ITEMS: 6.A-6.C

FILE NOS.:
CPC MP 02-00254-A3MJ14 - LEGISLATIVE
CPC ZC 14-00080 - QUASI-JUDICIAL
CPC CP 14-00081 - QUASI-JUDICIAL

PROJECT: POWERWOOD NO. 2 NORTH

FIGURE 1

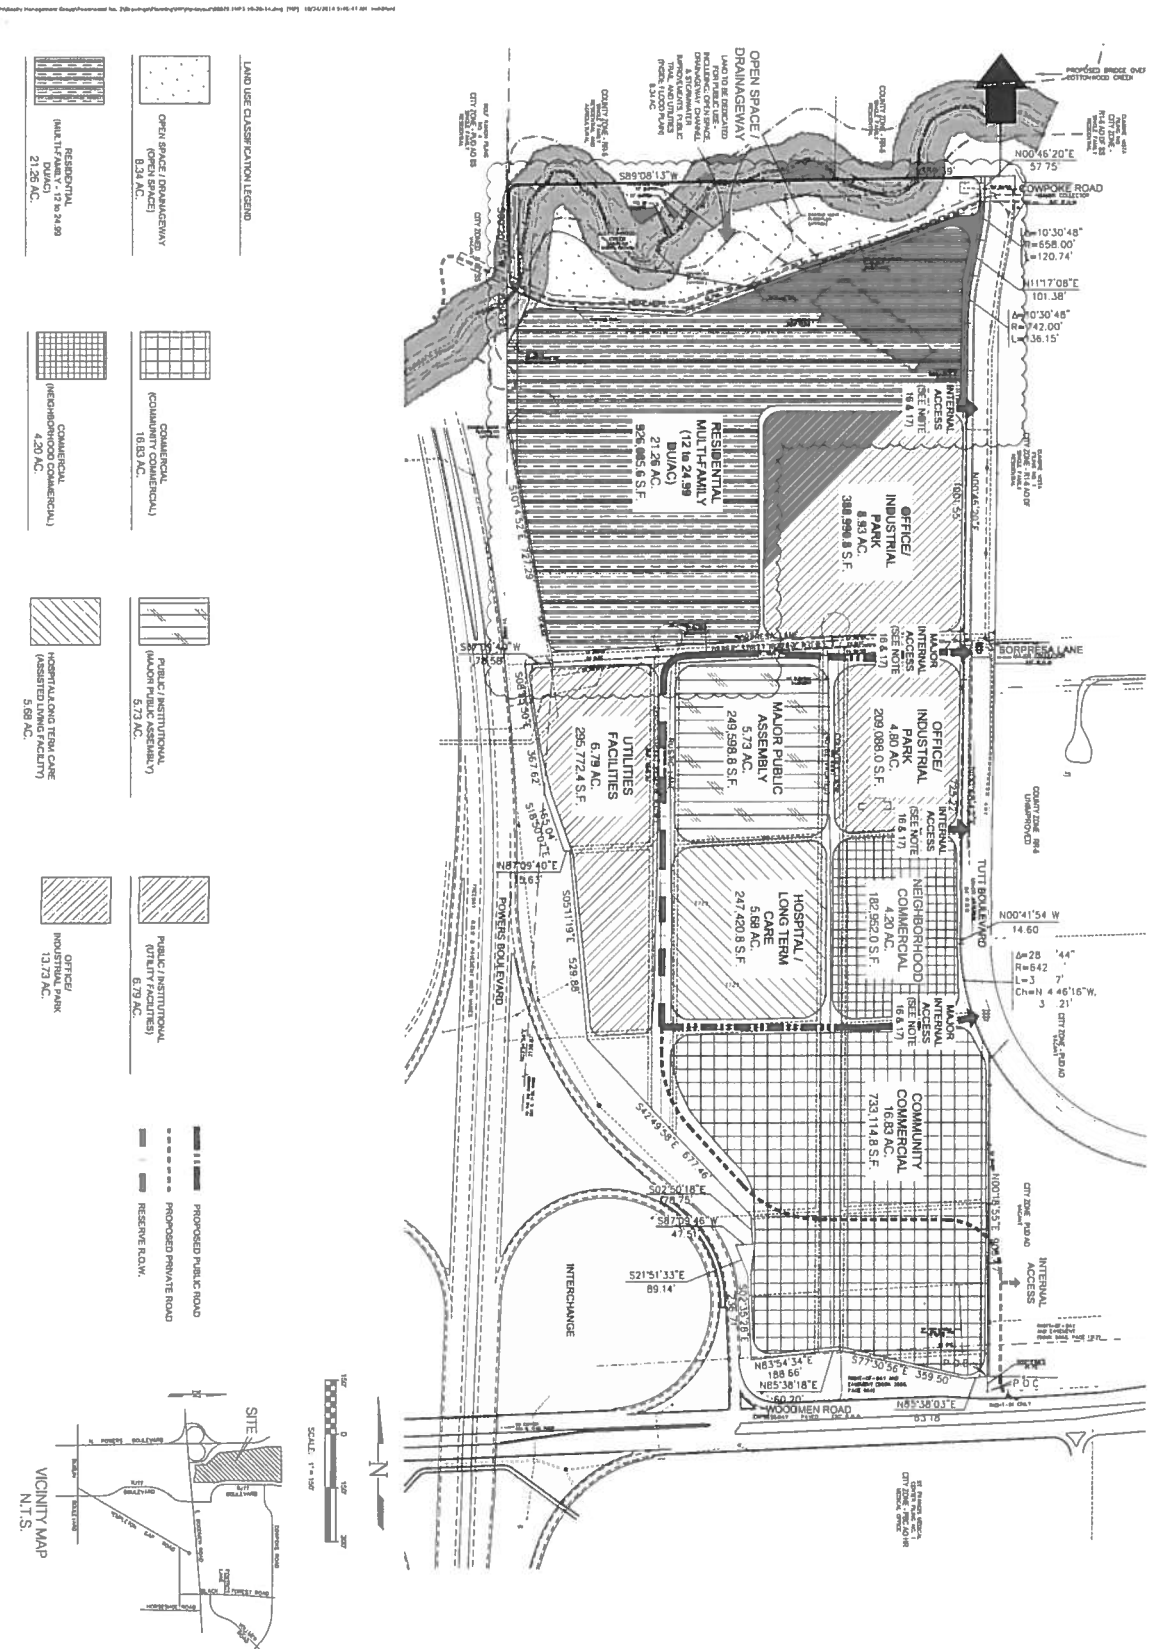
4. On the Sheet 2 graphic insert "Reserve R.O.W." between the neighborhood commercial and the community commercial pods.
5. On Sheet 2, align the proposed internal access with Sorpresa Lane.

6. The plan indicates a signal at the two proposed internal accesses with Tutt Blvd intersection. The Traffic Impact Analysis prepared by LSC on 10/24/2014 does not warrant signals at those intersections. On Sheet 2, remove the traffic signals shown on the plan

FIGURE 2

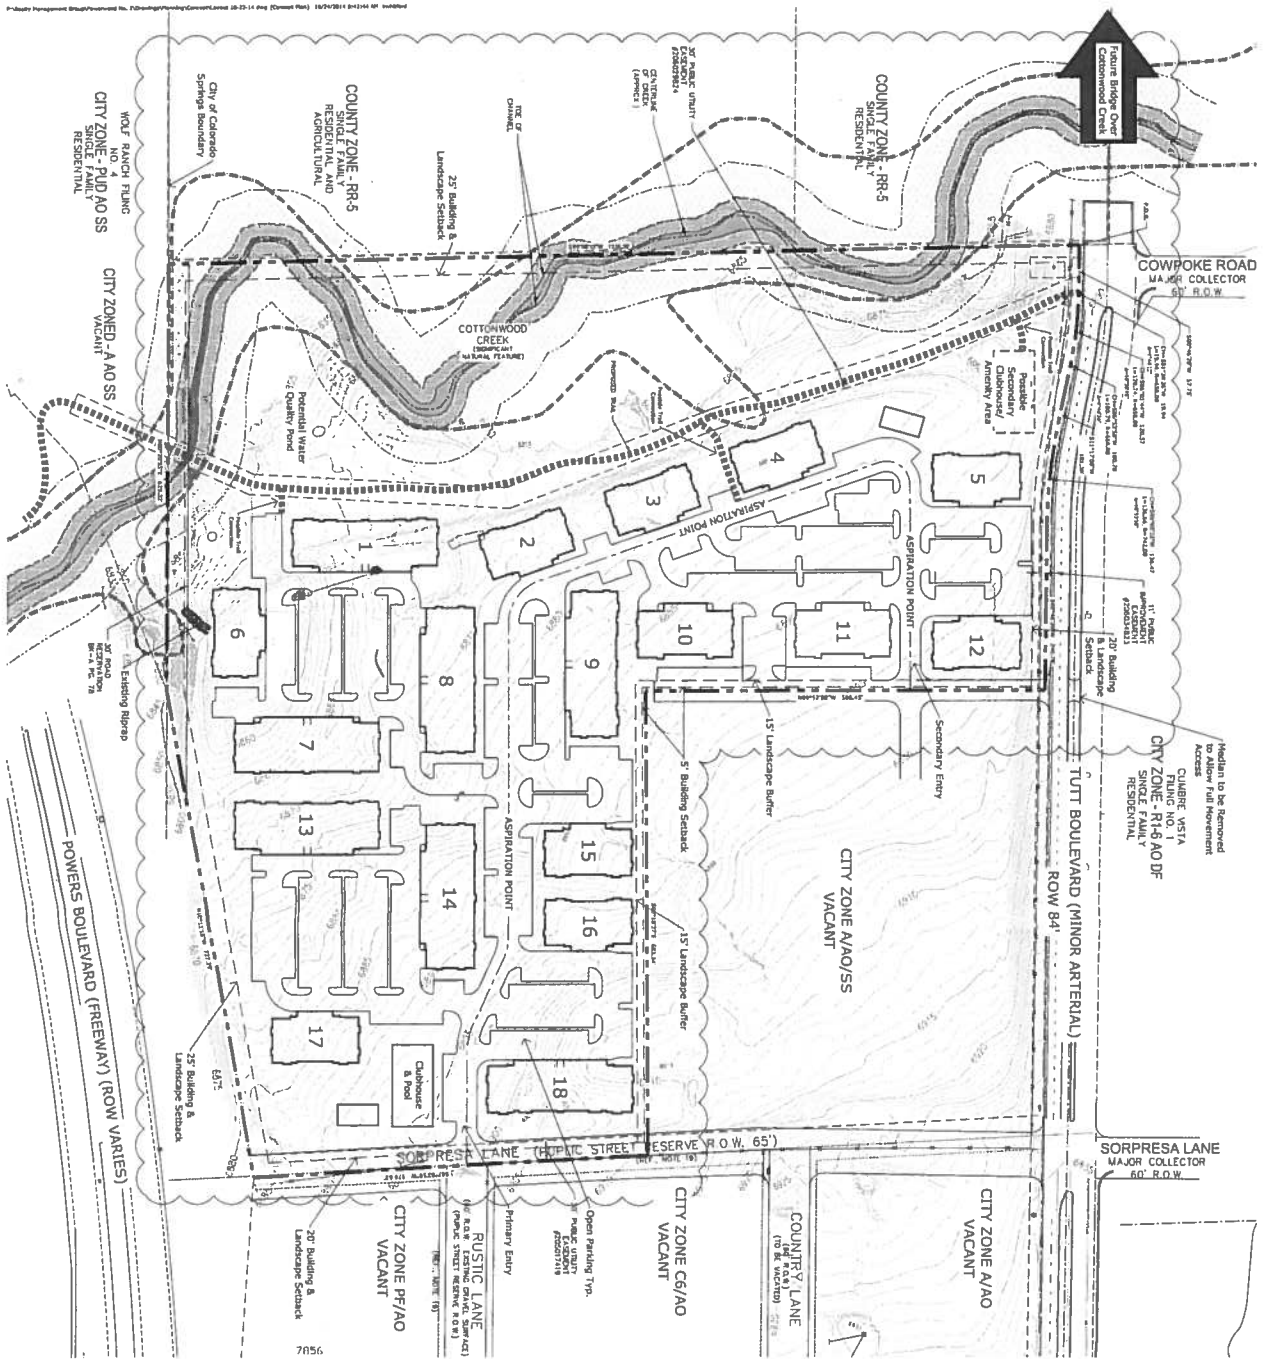
1. Show the City file number, "CPC CP 14-00081", in the lower right corner of the each sheet.
2. On Sheet 2, indicate the existing City boundary along the northern project boundary.
3. On Sheet 1, add the following new general note: "At the time of final plat recording, an Avigation Easement or proof of previous filing (book/page or reception number) will be provided".
